Access Compliance Report

Public Rights-of-Way

Intersection ID: 15049	Main Street: DILWORTH_RD_WEST	Cross Street: MAGNOLIA_AV	Location: NW
ADA ID: 91559A3C996D	Ramp Type: BlendTrans1	Initial Pass/Fail: Pass	Overall Compliance: No
Severity Score: 22.5			
Codes/Mitigation Info/Possible Solution		Field Measurements/Component Compliance

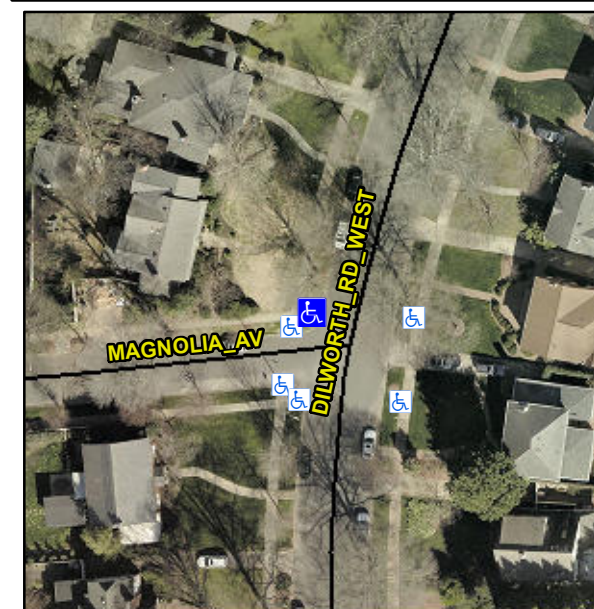
Remove & Replace Curb Ramp With Two New Directional Ramps or Equivalent. Remove & Replace Gutter.

R304.5.3, R305.1.4, R305.2, R302.7.2, R304.5.4
